Correspondence Between Staff and Applicant

Your Development Application 19-ZN-2013#2, Core Center, is scheduled on the 10/16/2019 Planning Commission hearing agenda.

**RE: 19-ZN-2013 #2 - Core Center  
1<sup>st</sup> Review Comment Responses – Traffic Study Specific**

**JULY 12, 2019 TRAFFIC STUDY-SPECIFIC REVIEW COMMENTS & RESPONSES**

**CORE CENTER**  
**84TH STREET LANE ALIGNMENT**  
**ACROSS HAYDEN ROAD, SHEET 1 OF 2**

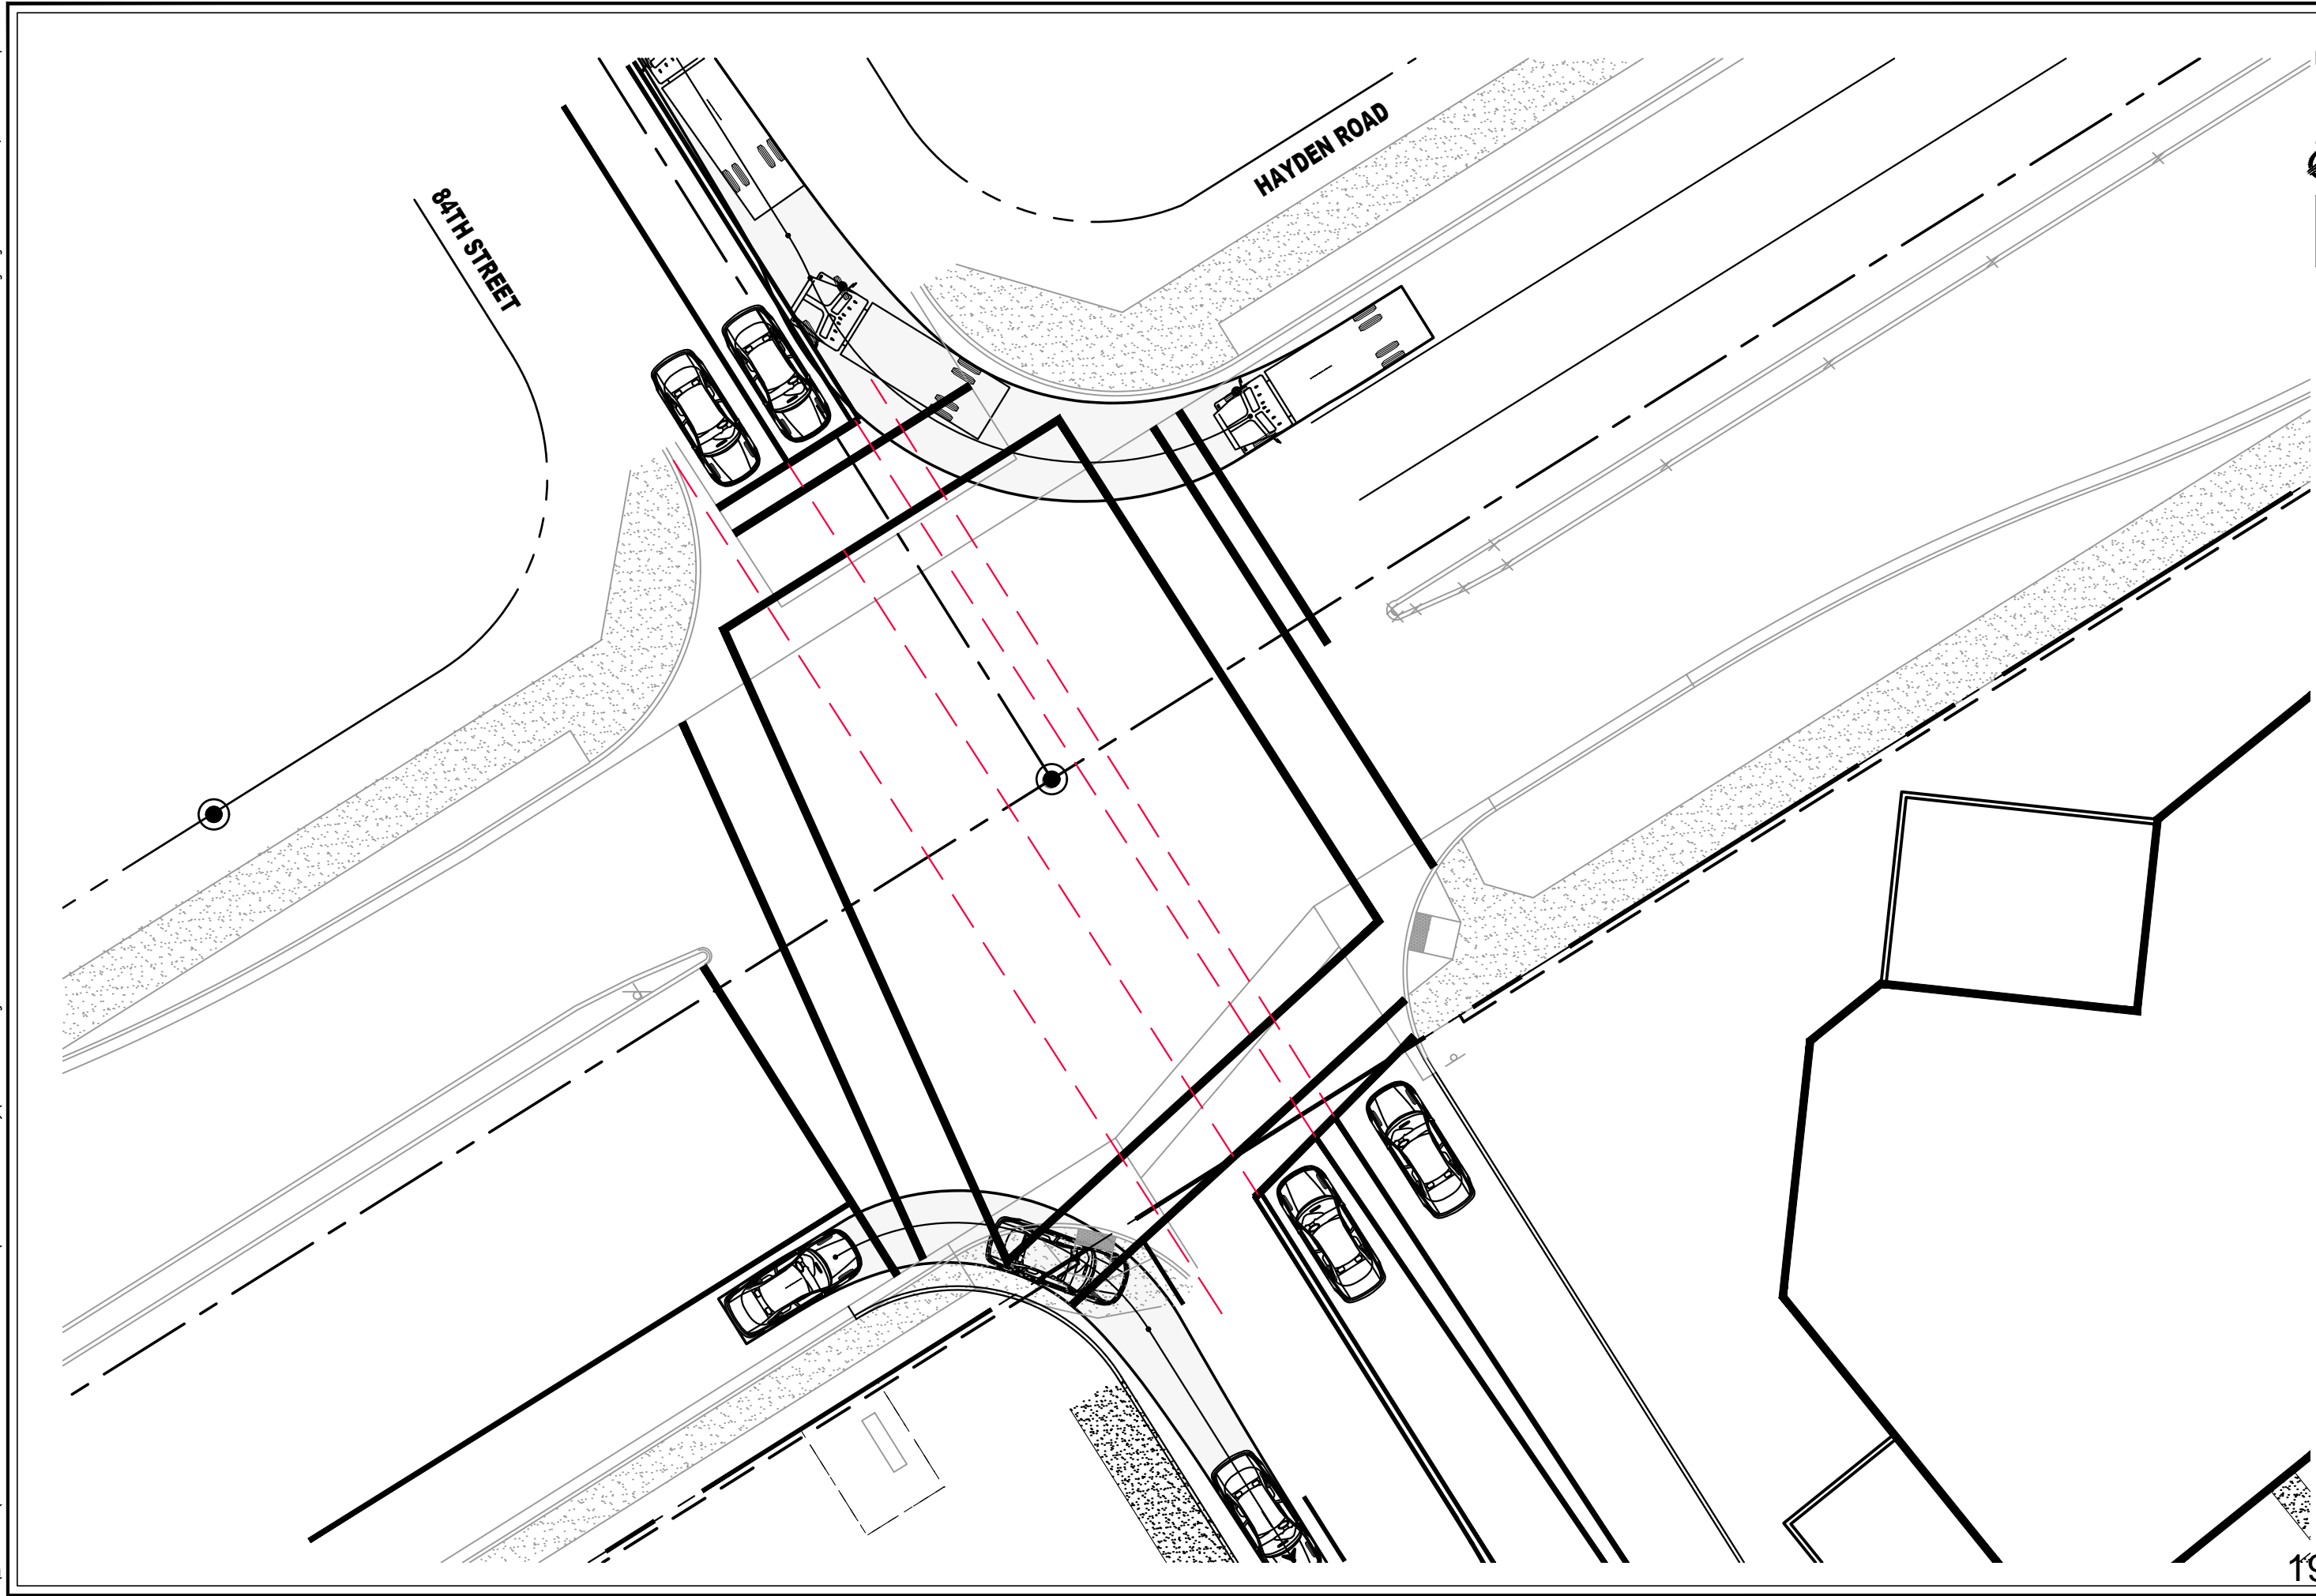
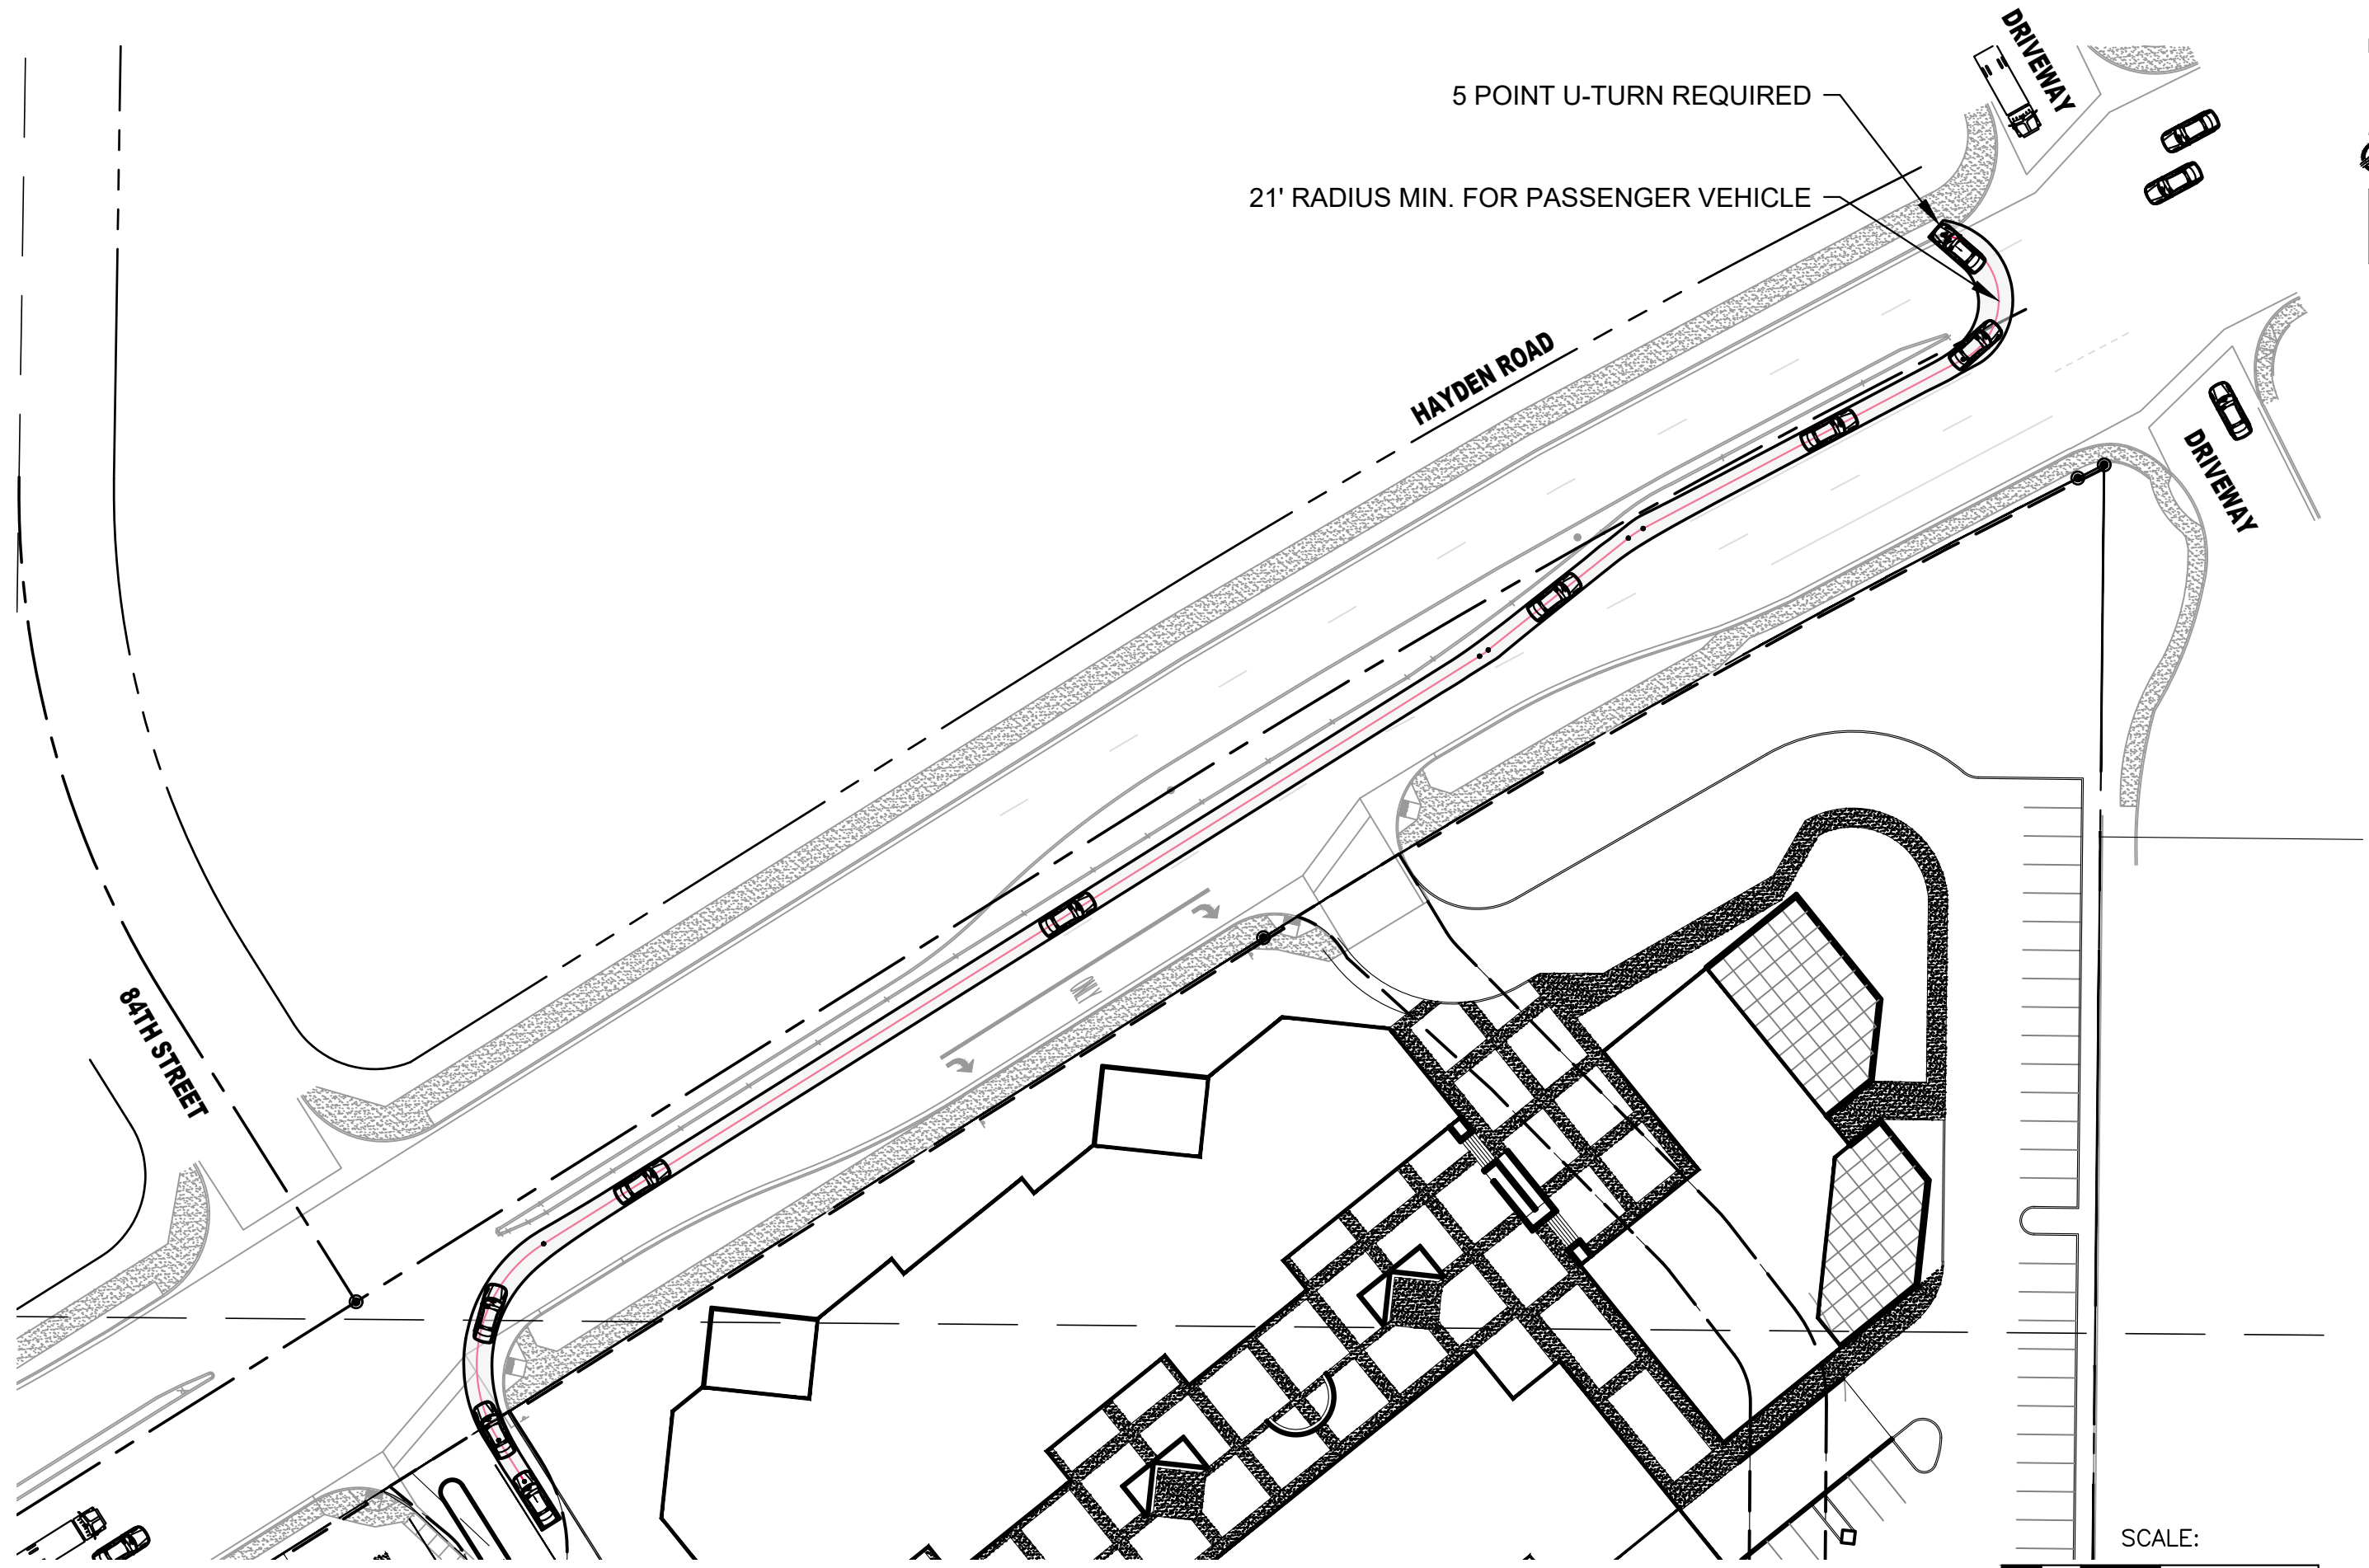
**COS Comment No. 24:** Page 31, 1st bullet (84th Street & Hayden Road), 3rd sentence - the site plan depicts a redesign of the existing site driveway. The developer is responsible for correct alignment of their proposed new driveway to prevent negative offset of left turning vehicles. Should the intersection be signalized, the developer will be responsible for improvements associated with the traffic signal, including and not limited to providing a left turn lane on all approaches. Please revise the project plans to address this comment. (Zoning Ordinance, Sec. 1.204.)

*The project plans have been revised to show curb line geometry and lane striping for the 84th Street driveway to achieve lane alignment north-south across Hayden Road. Two exhibits included with these review comment responses, Exhibit D1 and Exhibit D2, provide a little more detail of what was recommended for that area of the driveway near Hayden Road. Recognizing the site plan is still somewhat conceptual, a detailed assessment of internal circulation has not been performed as part this analysis.*
